UNITED STATES PATENT AND TRADEMARK OFFICE

10/799,143

Lutz Biedermann

Office Action Summary	Application No. 10/799,143	Applicant(s) BIEDERMANN ET AL.	
	Examiner MARY HOFFMAN	Art Unit 3733

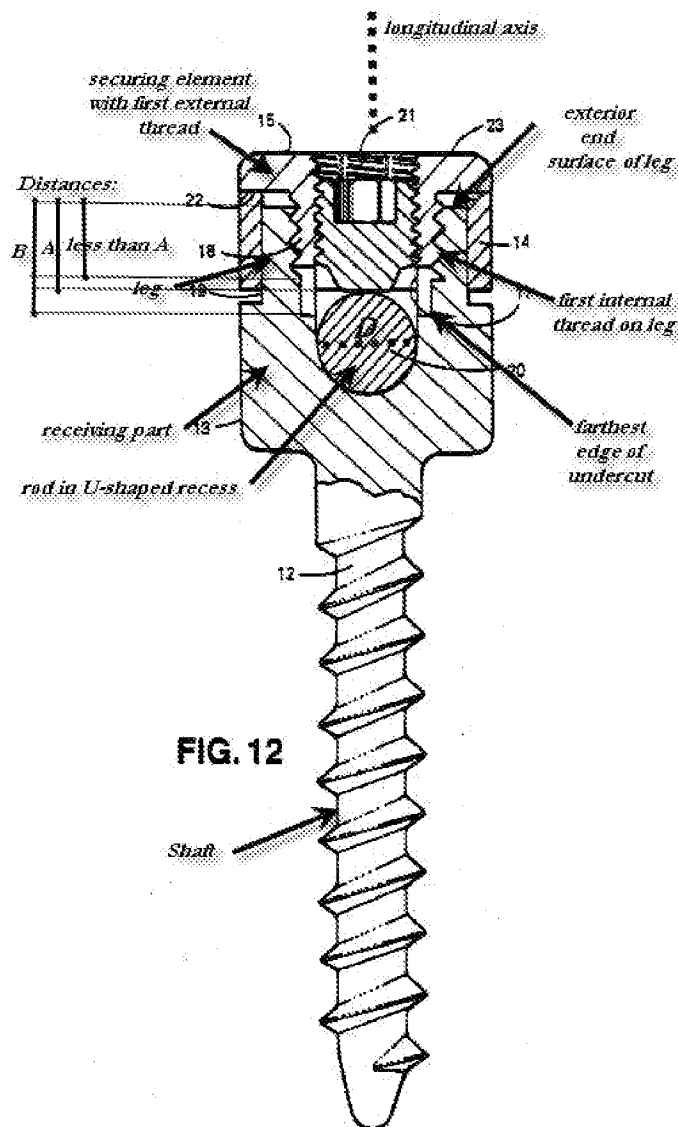
Mehdian discloses an anchoring element (See marked up figure below) for use in spinal or bone surgery; the anchoring element comprising: a shaft for anchoring in a vertebra or a bone section; a rod having a pre-determined diameter (D) and an outer surface; a receiving part, which is connected to the shaft and is structured and arranged to connect to the rod, the receiving part having a longitudinal axis and comprising a U-shaped recess forming a channel for the reception of the rod and two legs having free ends, the legs comprising a first internal thread, the legs further providing an exterior end surface of the receiving part; and a securing element (15, 21) comprising a screw member having a first external thread that engages and cooperates with the first internal thread; whereby a first distance from the exterior end surface of the receiving part to a closest portion of the outer surface of the rod in an axial direction is a pre-determined

distance (A); the first internal thread extending from the exterior end surface of the receiving part to a second distance that is smaller than or equal to the pre-determined distance (A); and the receiving part further comprising an undercut extending circumferentially and the first internal thread extending to the undercut, the undercut having an edge farthest away from the first internal thread, the edge being located at a third distance (B) from the exterior end surface, the distance (B) being larger than the predetermined distance (A). A connection between the shaft and the receiving part is structured and arranged to be a monoaxial connection. The shaft and the receiving part are an integral part. The first thread comprises fewer than four full turns.

Mehdian discloses the claimed invention except for the first external threads of the securing element being movable into the undercut and there being no thread runout at an end of the first thread opposite to the exterior end surface because the undercut is at least equal to a depth of the first thread.

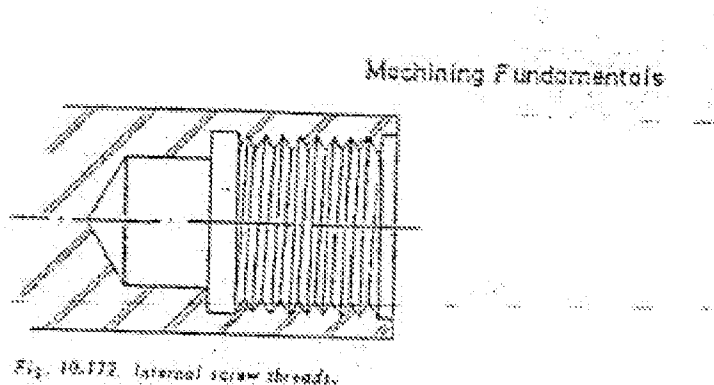
Walker discloses that internal threaded bores can be made using a standard technique which creates an undercut that allows the threads of a securing element to be

movable into the undercut and an undercut with no thread runout at an end of the first thread opposite to the exterior end surface because the undercut is at least equal to a depth of the first thread.

It would have been obvious to one of ordinary skill in the art at the time the invention was made to construct the device of Mehdian with first external threads of the securing element being movable into the undercut and there being no thread runout at an end of the first thread opposite to the exterior end surface because the undercut is at least equal to a depth of the first thread in view of Walker, since such is discloses as a standard technique for making internally drilled bores and would result in the functional equivalent of providing a threaded bore that mates with a securing element to fix a rod of the device into position.
